LOCKHEED AIRCRAFT CORP.		ENGINEERING STUDY <input type="checkbox"/>		LAC -93							
DATE 11-30-60		CHANGE PROPOSAL <input checked="" type="checkbox"/>									
NAME OF MAJOR COMPONENT O ₂ SYSTEM		PART OR LOWEST SUBASSEMBLY		PART NO. & MODEL OR TYPE							
TITLE OF PROPOSAL : OXYGEN SYSTEM IMPROVEMENTS											
NATURE OF PROPOSAL : SEE PAGE 2											
REASON FOR PROPOSAL : to incorporate supplemental safety provisions in the ships oxygen system to reduce fire hazard without detriment to existing efficiency. Proposed improvements include:											
<ol style="list-style-type: none"> 1. Use of slow opening manual control valves in place of present automatic opening connectors and the on-off feature of the pressure reducers to eliminate high pressure surges and resulting adiabatic heating. 2. Removing the cockpit low pressure gage to prevent possible misinterpretation of indicated pressures. 3. Relocating the modified pressure reducers and improved relief valves from the cockpit to the Q-bay within a box for protection against grease and dirt. Except for the high pressure gage, only low pressure oxygen will be plumbed to the cockpit.

NATURE OF PROPOSAL:

FIGURE 1.

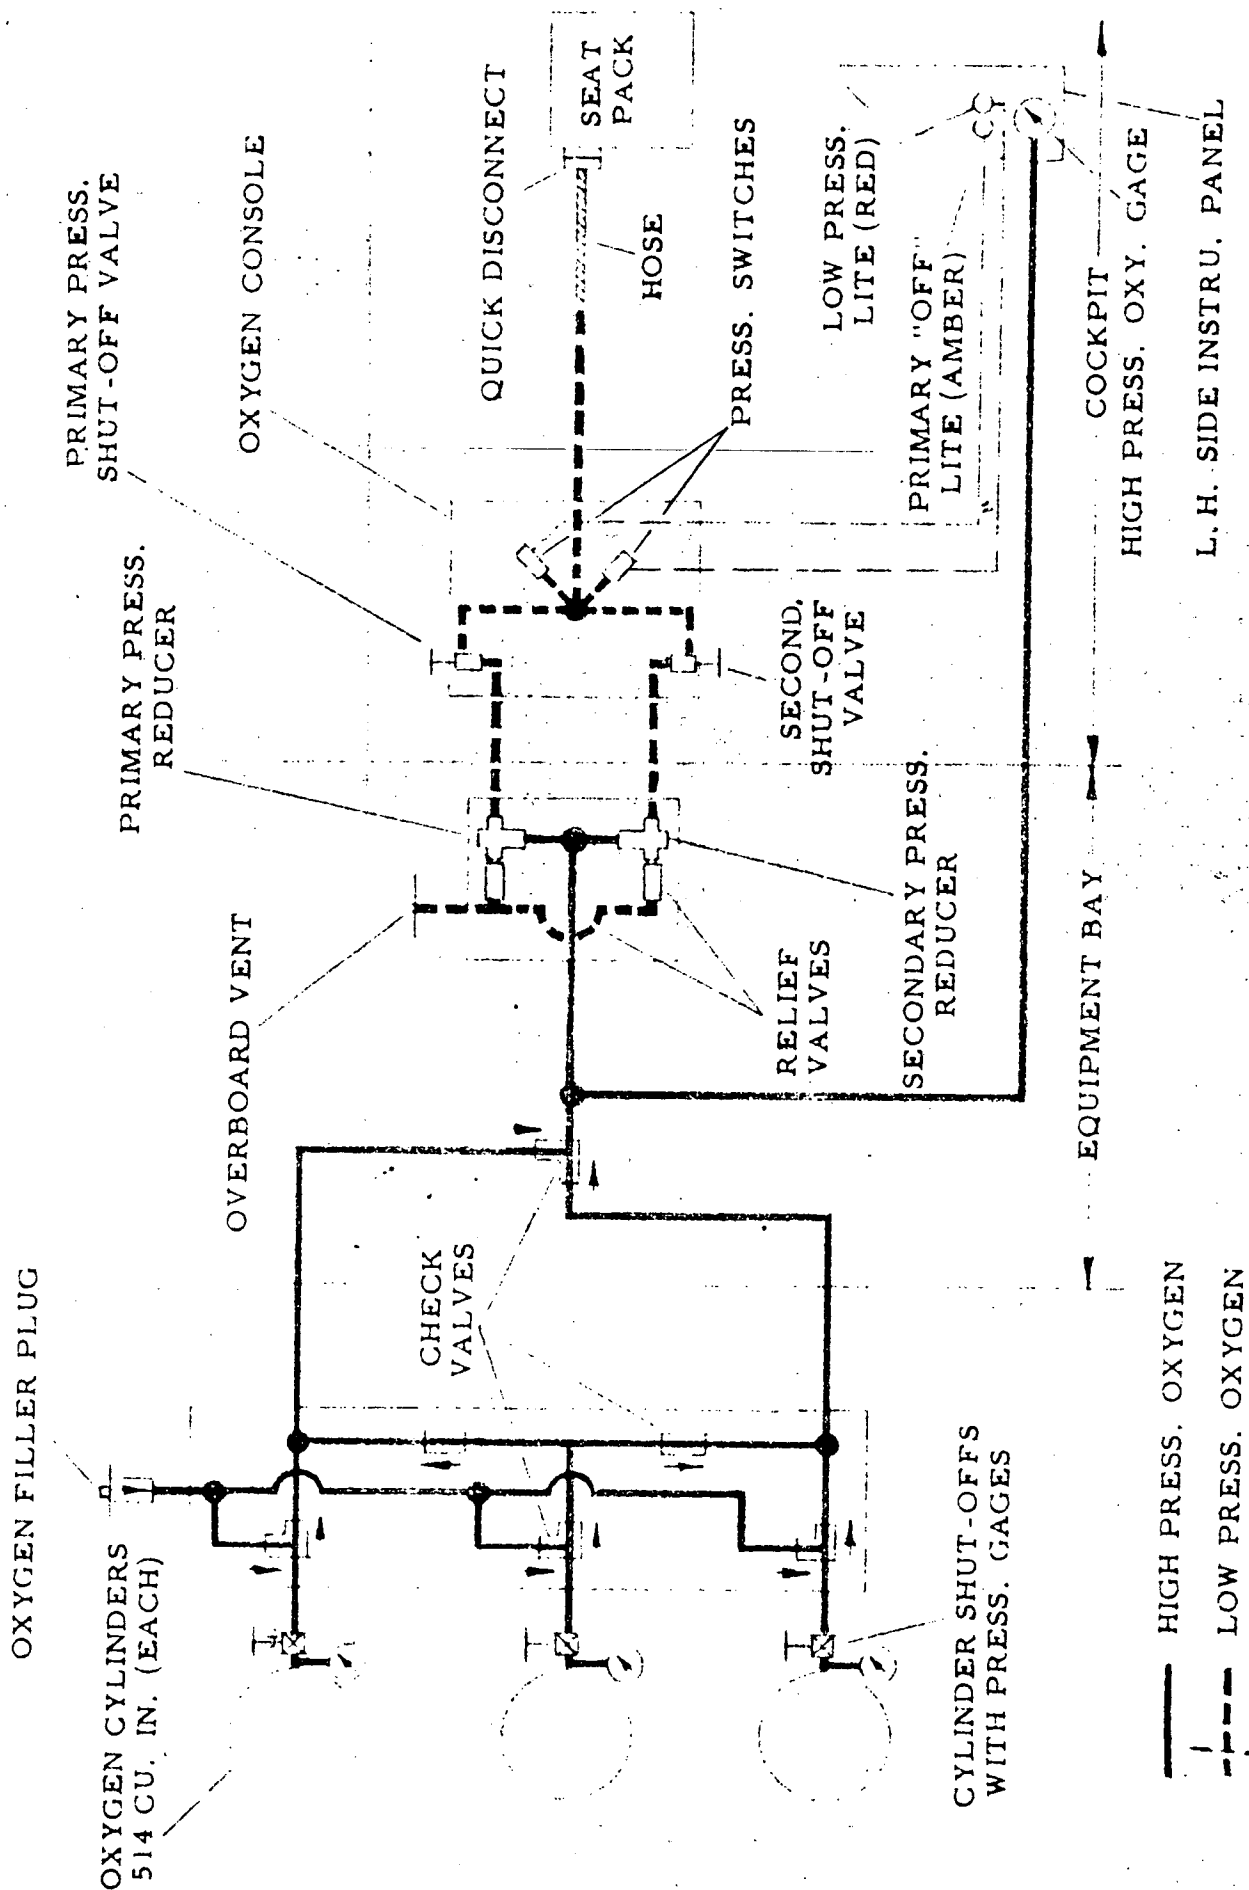
a. Cockpit - Remove all oxygen plumbing and system components except the high pressure gage and the indicator lights in the L. H. side instrument panel. Replace the present Oxygen Console with a new Console Assembly (Lo-pressure only) which includes the two existing pressure switches, and two new slow opening needle valves for controlling the "primary" and "secondary" low pressure systems. (See Figure 1.)
